Rezoning Transportation Analysis

Petition Number: 2026-033

General Location Identifier: 20108104

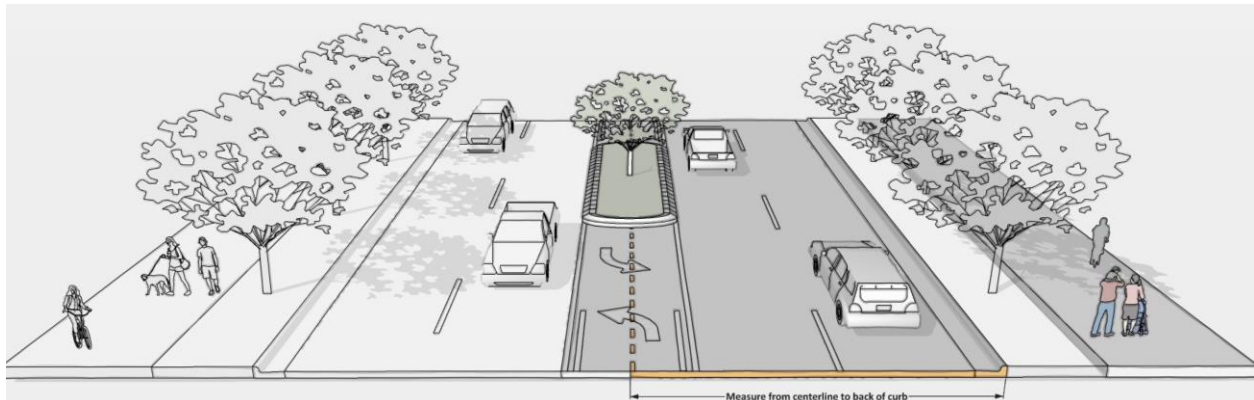
Petitioner to provide responses to the staff comments below as well as specify other changes to the site plan.
